**SB, FAN/IMPELLER - LOOSE BOLTS, EBZ8550,  
EBZ8550-RH, EBZ7500, EBZ7500-RH, 2021-11**

**Service Bulletin  
B2210007A-15**

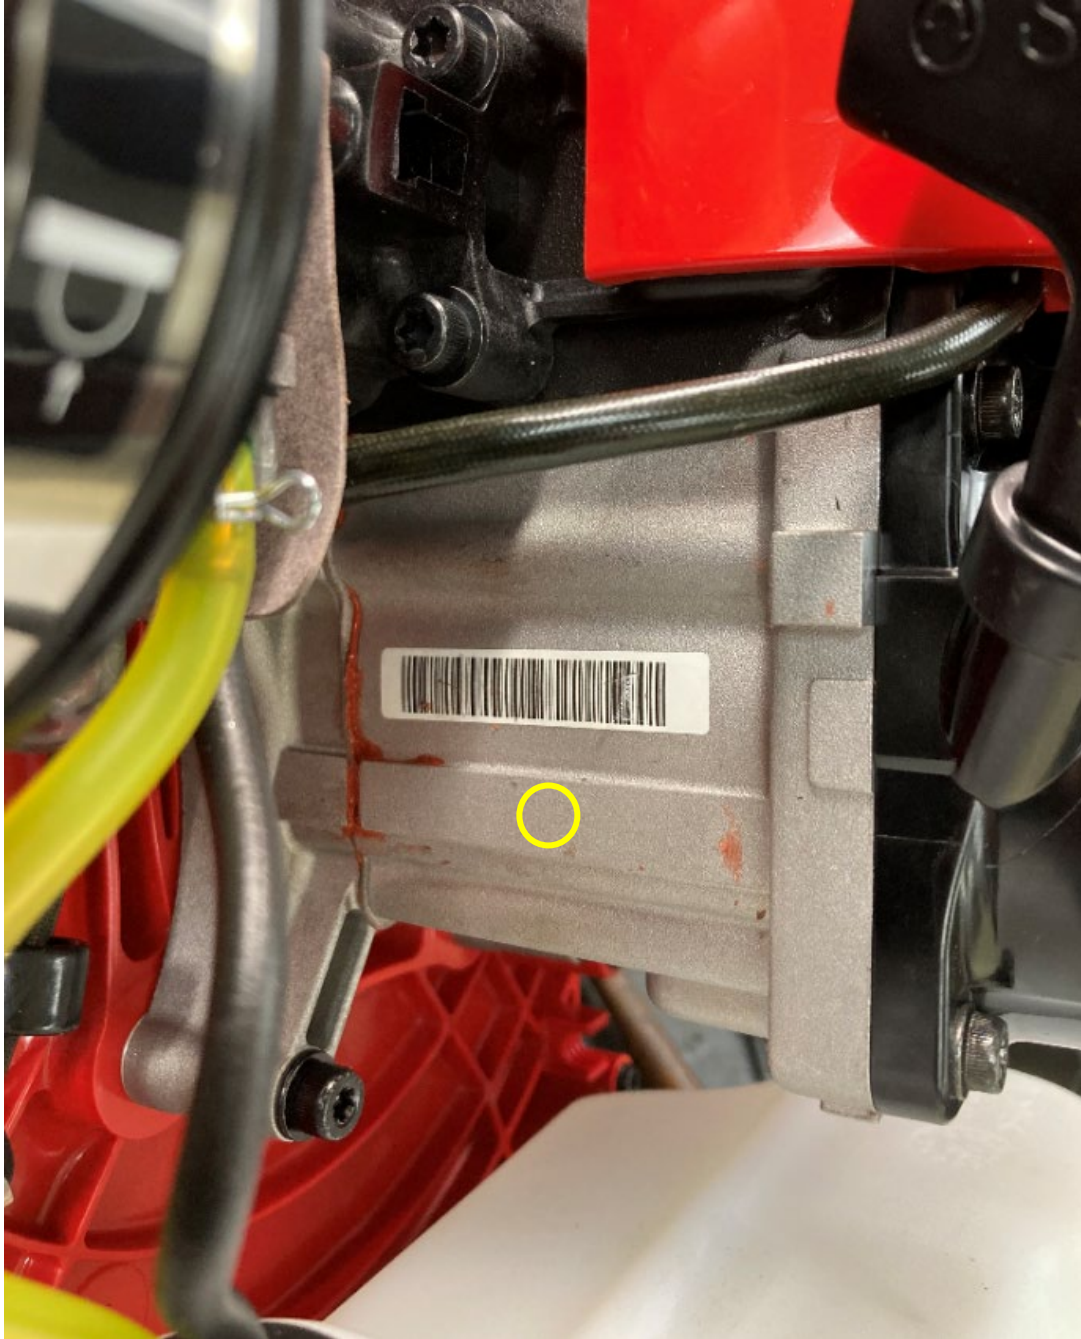
After inspection and/or repair, mark the unit with a spring loaded center punch in the following yellow circled area to indicate that the unit's impeller bolt torques are within the specified design limits.
